## North Shore Geo, PLLC

Subject: **GEOTECHNICAL REVIEW  
STATE OF WASHINGTON DEPARTMENT OF NATURAL RESOURCES (DNR)  
FOREST PRACTICES APPLICATION (FPA) NO. 2618493  
“TREE WELL” TIMBER SALE  
CLALLAM COUNTY, WASHINGTON**

Figure-1: FPAMT Map with Annotations for Unit 3

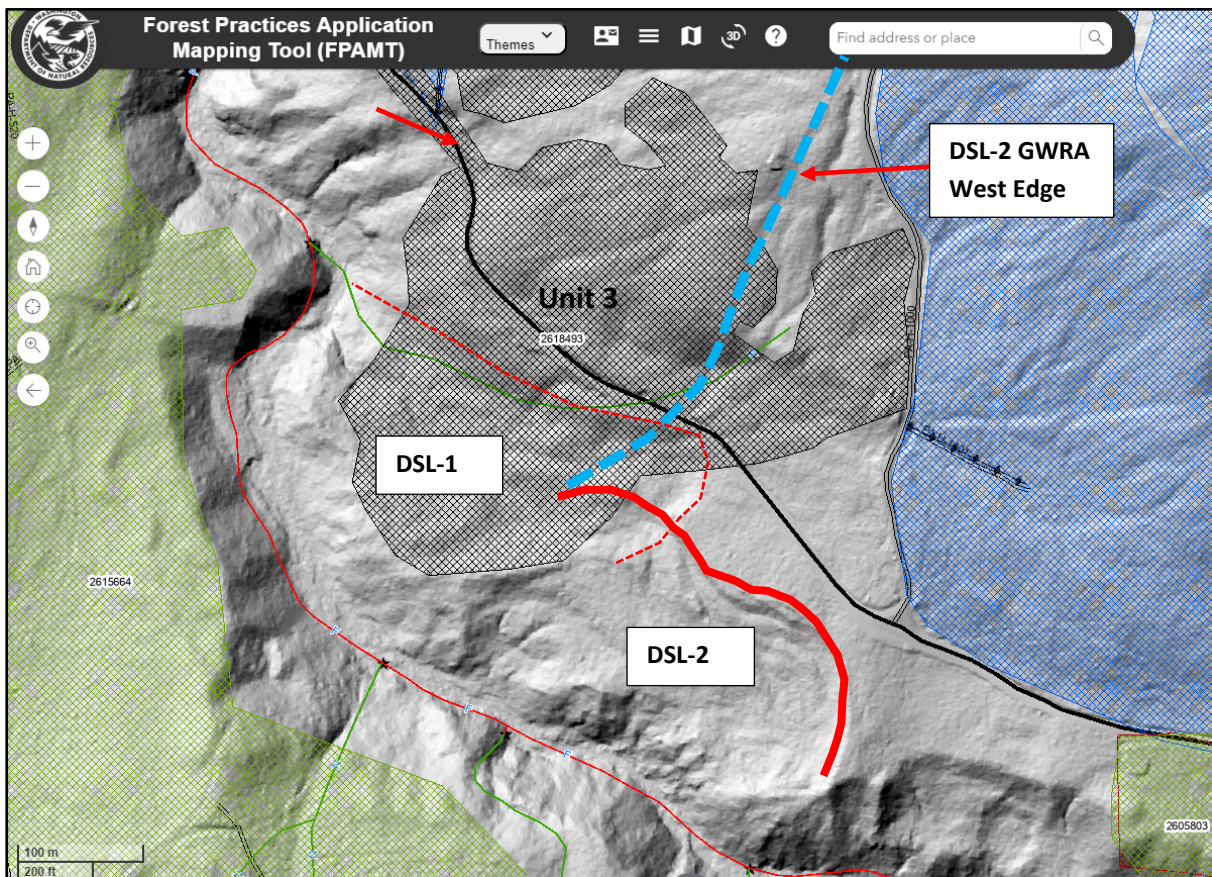
In my opinion the GFS for the subject timber sale does not appear to have considered all of the relevant slope stability hazards for the proposed harvest and should be reclassified as a Class IV special or the east edge of unit 3 should be moved to the west as shown in my figure-1 below.

The downhill / southwest edge of unit 3 includes DSL-1 and DSL-2 as described in the GFS report. The topographic groundwater recharge area (GWRA) for DSL-2 is bound out of the sale as a RIL which would typically require reduced harvest. Harvesting in a RIL would typically mean that the timber sale would have to be a Class IV special, rather than the Class III which it is under the current FPA. The northwest edge of the GWRA for DSL-2 defines the southeast edge of unit 3, as shown on the Forest Practices Application Mapping Tool (FPAMT) website (<https://fpamt.dnr.wa.gov/2d-view>), as shown in my figure-1 below. I have annotated figure-1 with red (apparent DSL-2 scarp) and blue (northwest edge of GWRA) to illustrate my opinion of the conservative location of these two features. It appears to me that a significant portion of the east edge of Unit 3 should be removed from the timber sale.

Because DSL-2 has significantly more recent activity than DSL-1, and DSL-1 has been classified in the GFS report as a relict bedrock DSL or not a landslide at all, the GWRA for DSL-2 must be updated, similar to what I show above. It appears to me that this GWRA is the one shown for DSL-2 from the Black Diamond timber sale FPA 2617163 when DSL-1 also had a GWRA.

It is my opinion that DSL-2 should be considered active and not dormant-distinct to dormant-indistinct due to the active scour from the Little River at the toe of the landslide causing abundant shallow landslides and the crisp head-scarp features. This DSL would deliver sediment to the Little River fish stream at the toe and would threaten the Little River Road if future activity expanded the slide uphill.
